Proposal for supplement 5 to the original version of UN Regulation No. 151 (Blind Spot Information Systems)

**Submitted by the expert from the Kingdom of the Netherlands on
behalf of the Task Force on Automated Vehicles Regulatory Screening***

The text reproduced below was prepared by the Task Force on Automated Vehicles Regulatory Screening (TF-AVRS), with the aim to amend and supersede document ECE/TRANS/GRSG/2025/38. The modifications to ECE/TRANS/GRSG/2025/38 are marked in **(bold)** red for new or ~~strikethrough~~ for deleted characters.

"Annex 2 - Arrangements of approval marks

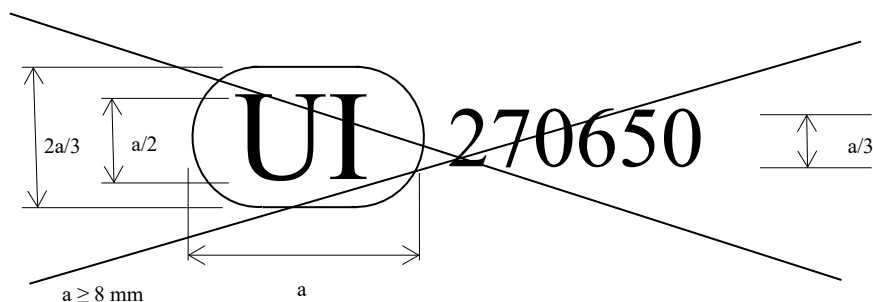
Annex 2, amend to read:

~~The above Unique Identifier shows that the type concerned has been approved and that the relevant information on that type approval can be accessed on the UN secure internet database by using 270650 as Unique Identifier. Any leading zeroes in the Unique Identifier may be omitted in the approval marking."~~

The above approval mark affixed to a vehicle shows that the vehicle type concerned has been approved in Germany (E1) with regard to BSIS pursuant to UN Regulation No. 151. The first two digits of the approval number indicate that the approval was granted in accordance with the requirements of UN Regulation No. 151 in its original form.
